**HISTORIC PRESERVATION REVIEW BOARD  
STAFF REPORT AND RECOMMENDATION**

Landmark/District: **Walter Reed Army Medical Center Historic District** (x) Agenda  
Address: **6825 16<sup>th</sup> Street NW**

Meeting Date: **November 17, 2016** (x) Alteration  
Case Number: **17-048**

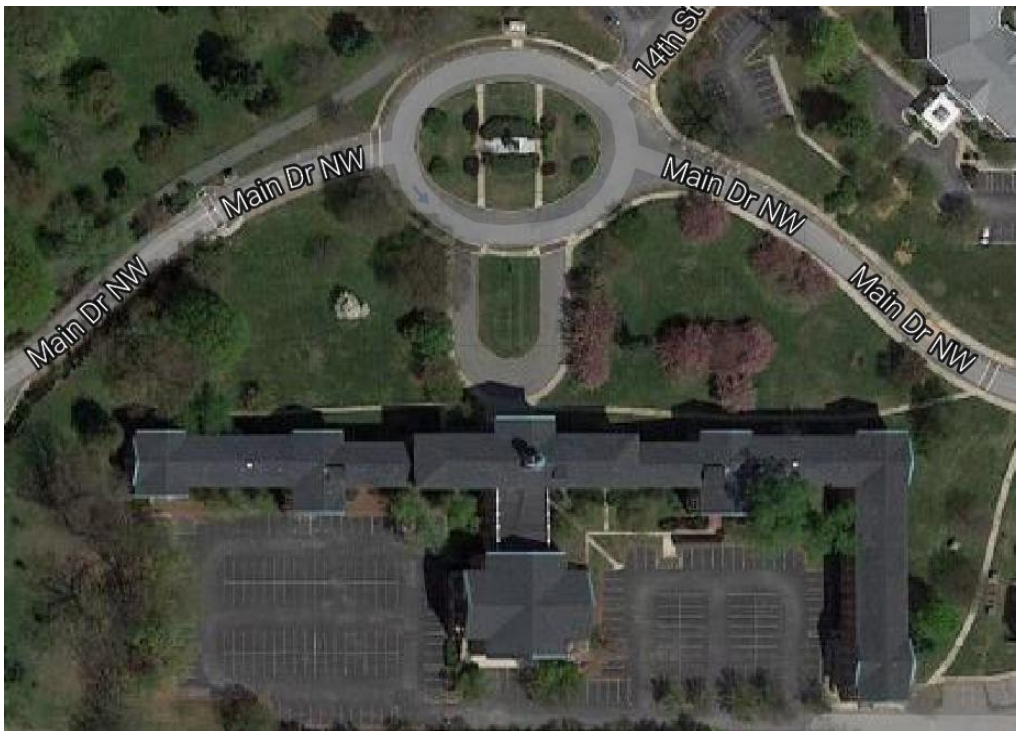
The site plans depict five features, four of which are more than one foot deep, and the fifth more than half a foot. Their area would total nearly 26,000 square feet. They would be located along the frontage of the wings that flank the building’s central pavilion, filling the space between the building’s face and the lead walk that runs roughly parallel. Accompanying photographs indicate the intention to fashion these depressions into rain gardens with a variety of plants.

Rain gardens directly in front of this building would not be compatible with the landscape character of the Walter Reed Army Medical Center Historic District.

Landscape plans for each historic building and for the campus as a whole should build upon the historic landscape features. Beyond the depressions that they require, rain gardens are too informal for the context of most front yards, especially formally planned ones. Draft design guidelines for the campus, first reviewed by the Board in July, recommend that,

Alternative locations for the proposed rain gardens, alternative means for dealing with the runoff, such as a cistern, or a waiver from the requirements should be explored.

*HPO recommends that the Board recommend against a permit for the proposed stormwater features as incompatible with the character of the property and the historic district and thus contrary to the purposes of the preservation law.*
